**Re: Orica Southlands Lot 9 (SSD-9691) – Proposed Warehouse Development
28 McPherson Street, Banksmeadow
Response to Road Safety Audit**

Concept design road safety audit

TRAFFIX Response to RSA

Table 2 Road safety audit findings

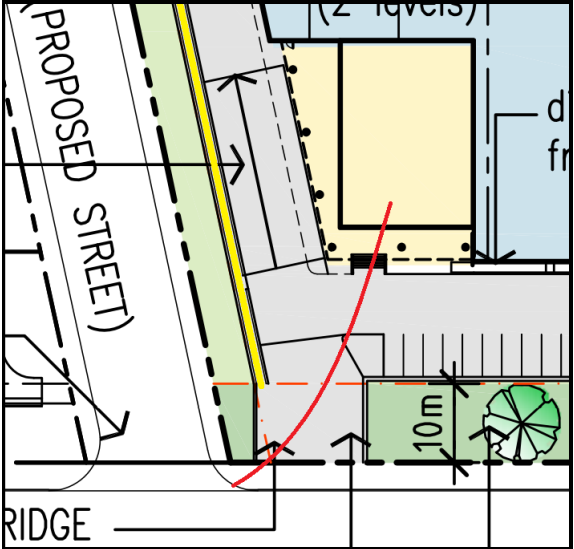
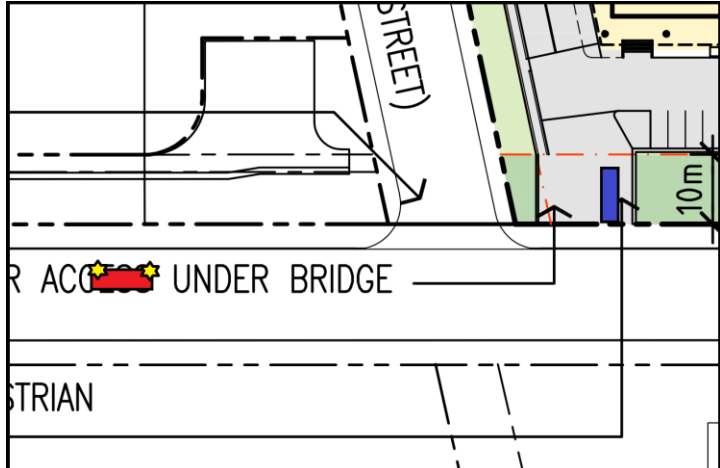
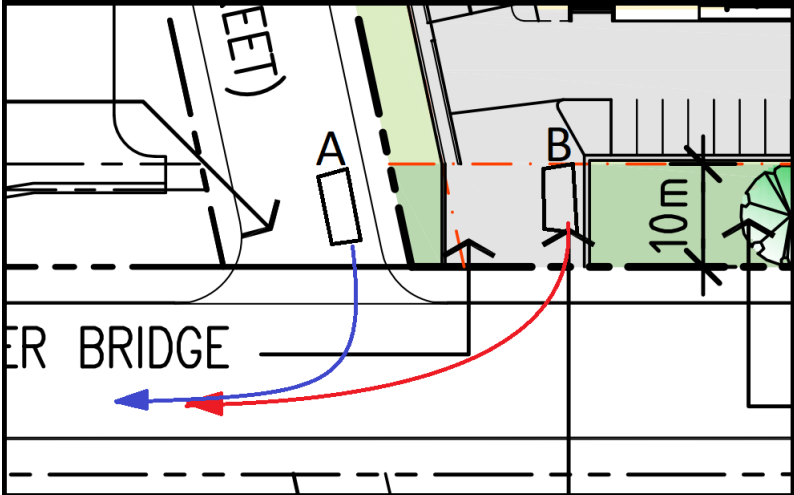
Ref	Location	Road safety audit findings	Priority
1a	Egress movements from the property driveway.	<p>The proposal includes a driveway which will stem off the northern side of McPherson Street. The design indicates that there would be landscaped areas on the northern verge of McPherson Street either side of the driveway. However, the vegetation type was not specified. There is a risk that if tall shrubs or trees are planted, these may obstruct the following sightlines to the driveway.</p> <ul style="list-style-type: none"> ▪ The <i>stopping sight distance</i> (SSD) from eastbound drivers on McPherson Street to the driveway. This is the sight distance needed for eastbound drivers to detect a potential hazard emerging from the driveway, to react and then brake to a full stop. Figure 3.2 of AS2890.1 indicates that for a 50km/h design speed, an SSD of 45m would be required. The SSD by westbound drivers (ie. by drivers on McPherson Street approaching the driveway from the east) is less critical since (i) this traffic stream would be further (laterally offset) from the northern kerblines and driveway of the road and hence less likely to be obstructed by landscaping and (ii) there would be substantially less traffic approaching the site from this side since it is a terminating road with a cul-de-sac. ▪ The <i>minimum gap sight distance</i> (MGSD) from egressing drivers in the driveway to the east and west. These are the sight lines needed by an egressing driver to view approaching traffic and detect and select safe gaps to turn out of the driveway. Figure 3.2 of AS2890.1 adopts a critical gap time of 5 seconds which equates to an MGSD of 69m at a 50km/h design speed. <p>These risks would be appropriately mitigated by keeping the landscaping in the northern verge, particularly along the sight lines discussed above, to low-height species only. This includes any support frames used during the establishment period.</p> <p><i>NB. The audit team notes the potentially sight-obstructing impacts due to parked cars, trucks and trailers on the northern kerblines. However, this was not raised as a formal audit finding since this is common practice along McPherson Street, and any such parked vehicles would also tend to have a speed-limiting effect compared with vacant kerblines. As such, whilst parked vehicles/ trailers may restrict sight lines, they also reduce demand for sightlines by virtue of the lowered traffic speeds.</i></p>  <p>Above: The egressing driver will need clear MGSD sight lines to detect and select safe gaps to enter McPherson Street. The red lines are used to illustrate the potential impact to the MGSD sight line if constrained by (i) tall vegetation planted in area X and (ii) if the trees to the west of the driveway are tall and sight-obstructing.</p>	High

Ref	Location	Road safety audit findings	Priority
1b	Egress movements from the property driveway.	<p>Further to item 1a, the egressing driver will also need to be aware of any pedestrians that may suddenly move into a crash conflict space. For example, a pedestrian at the Nant Street right-of way (labelled "ped" and circled in red) may emerge into the space of the egressing vehicle (blue rectangle) with risks of <i>vehicle-pedestrian</i> crashes. This is especially if the pedestrian is obscured by tall landscaping or boundary fencing. With respects to the latter, the right-hand image shows the extremely limited "see-through" visibility through this palisade fence used on the adjacent property to the west. The combined effect of the closely spaced balusters and the acute viewing angle towards and "through" the fence means that drivers would not have clear visibility to the area behind the fence. The same risk could arise with egressing drivers and pedestrians emerging from the sides of the driveway.</p> <p>Similarly, egressing drivers will need clear sight lines to any pedestrians at point "Y". This means this area should also be kept free of tall and sight-obstructing vegetation and the impact of any boundary fencing should also be considered.</p> <div data-bbox="521 501 1731 1011"> </div> <p>Left: Extract from the design showing the potential risks of vehicle-pedestrian crash risks if pedestrians emerge into a crash conflict space with the egressing driver without any warning or advanced expectation. Right: The palisade fences used along most properties along McPherson Street have limited "see-through" visibility due to the closely spaced balusters and the acute viewing angle.</p>	High

Audit Reference Number(s)	Location	TRAFFIX Response
Item 1a <i>High Priority</i>	Egress movements from the property driveway	<p>TRAFFIX has reviewed the audit team findings and considers the potential risks associated with stopping sight distance (SSD) and minimum gap sight distance (MGSD) at the proposed vehicular access to be minimal, noting the following key aspects:</p> <ul style="list-style-type: none"> • Orica will retain ownership of the front 10 metres of the site, which contains critical ground water infrastructure. The 10 metre strip currently contains landscape, with existing GTP infrastructure unable to permit additional planting. Therefore, the proposal does not include any additional planting or landscaping that will obstruct SSD/MGSD areas; • Existing palisade fencing to be retained to protect GTP infrastructure; and • Any obstructions that can potentially obstruct SSD/MGSD areas are to have a maximum height of 600mm. <p>In light of the above, the SSD and MGSD areas within the site will effectively remain clear, thereby mitigating any potential risks associated with sight distance visibility for egressing drivers of the development.</p>

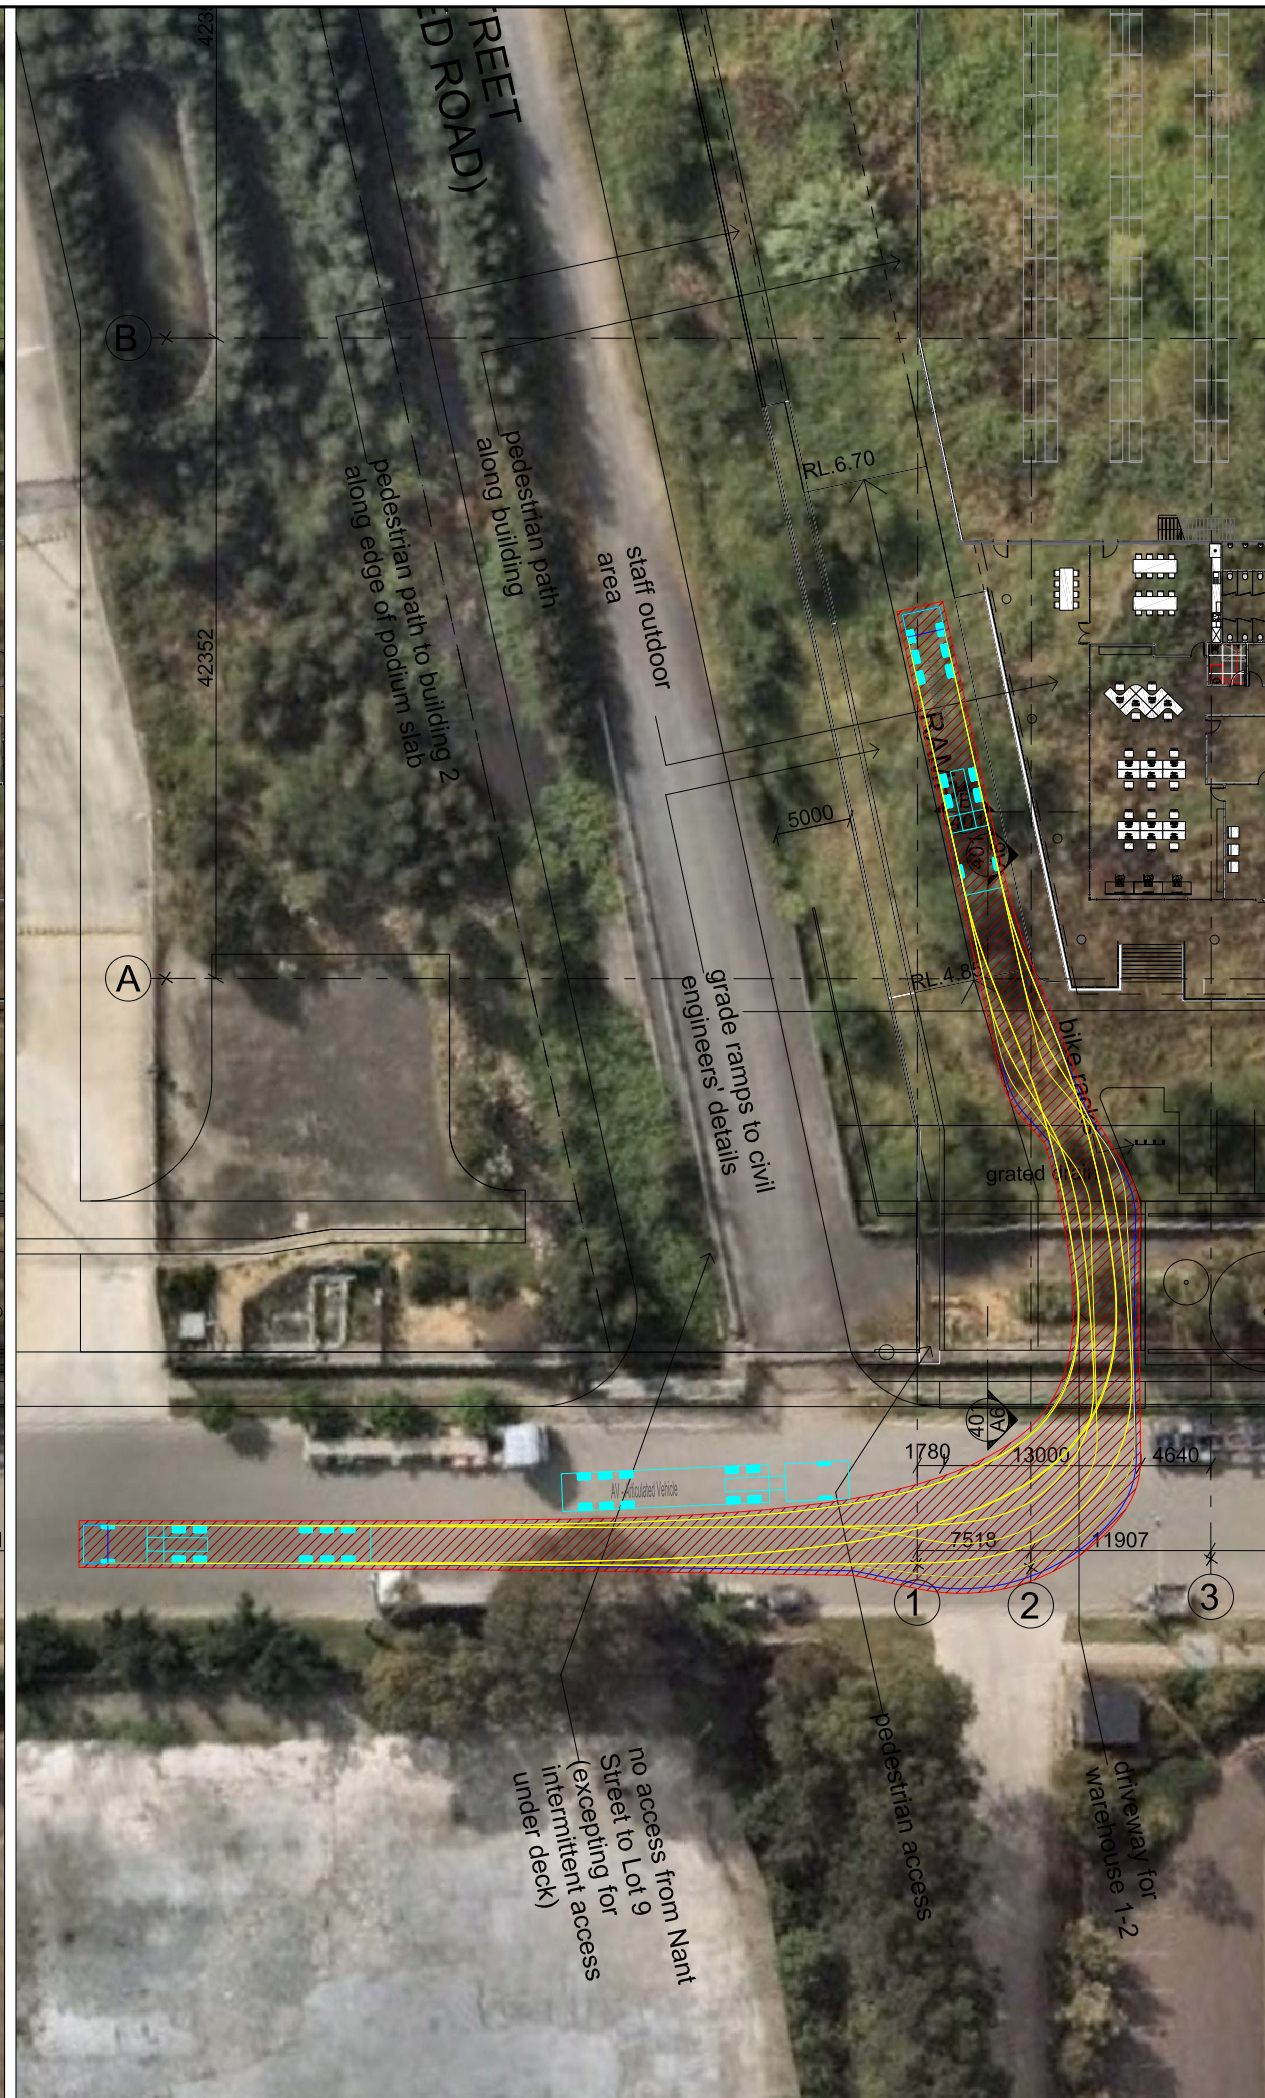
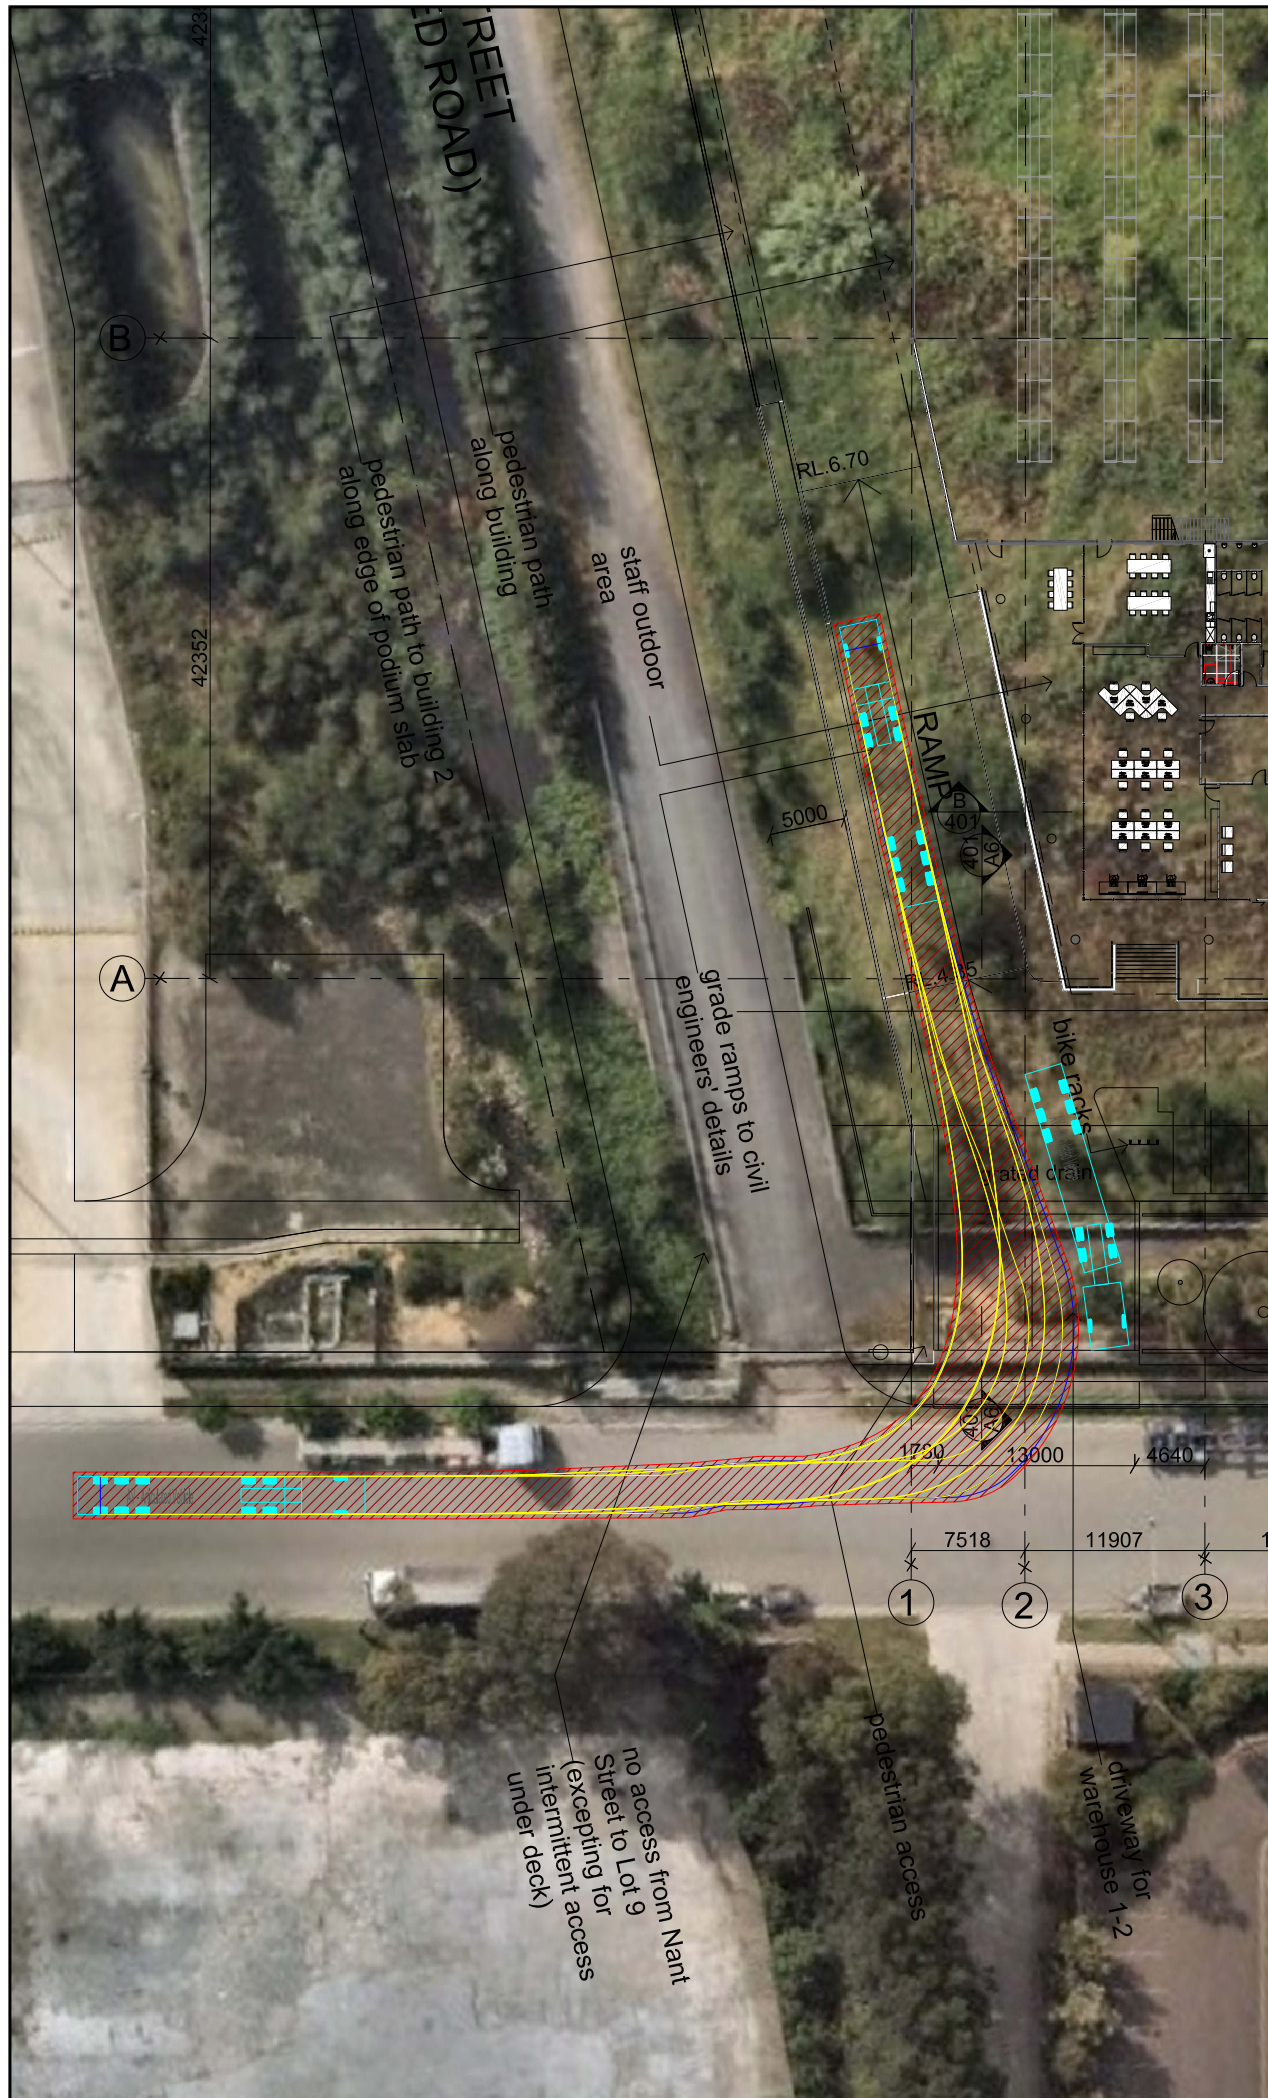
Item 1b <i>High Priority</i>	Egress movements from the property driveway	<p>The proposed vehicular access is provided 2.5m x 2.0m visual sight splays for egressing drivers, as required under AS2890.1 (2004) Figure 3.3. These visual sight splays are proposed to be clear of any obstructions to visibility, noting the following exceptions:</p> <ul style="list-style-type: none"> • Palisade fencing or any other fencing that will not obstruct an egressing driver's visibility. It should be noted that palisade fencing is widely utilised at the vehicle access for several warehouse developments to enable egressing drivers to identify potential pedestrians at the vehicle access; and • All obstructions (excluding palisade fencing) and landscaping are to have a maximum height of 600mm, which is consistent with various councils. <p>In addition to the above, it is noted that Nant Street is primarily utilised as the main access for the Qenos Tank Farm, located to the immediate north of the site on an intermittent basis only. The unformed Nant Street sits within the flood storage area for the local area, which would require considerable filling in order to transform Nant Street into a usable heavily trafficked road. Accordingly, Nant Street is highly unlikely to become a more trafficable road and does not accommodate general vehicle or pedestrian traffic, with a rarely opened gate restricting public access to the road. As such, pedestrian activity from Nant Street is envisaged to be considerably low (if any).</p> <p>In summary, the above arrangements are considered appropriate to satisfy the requirements of AS2890.1 (2004), therefore considered acceptable.</p>
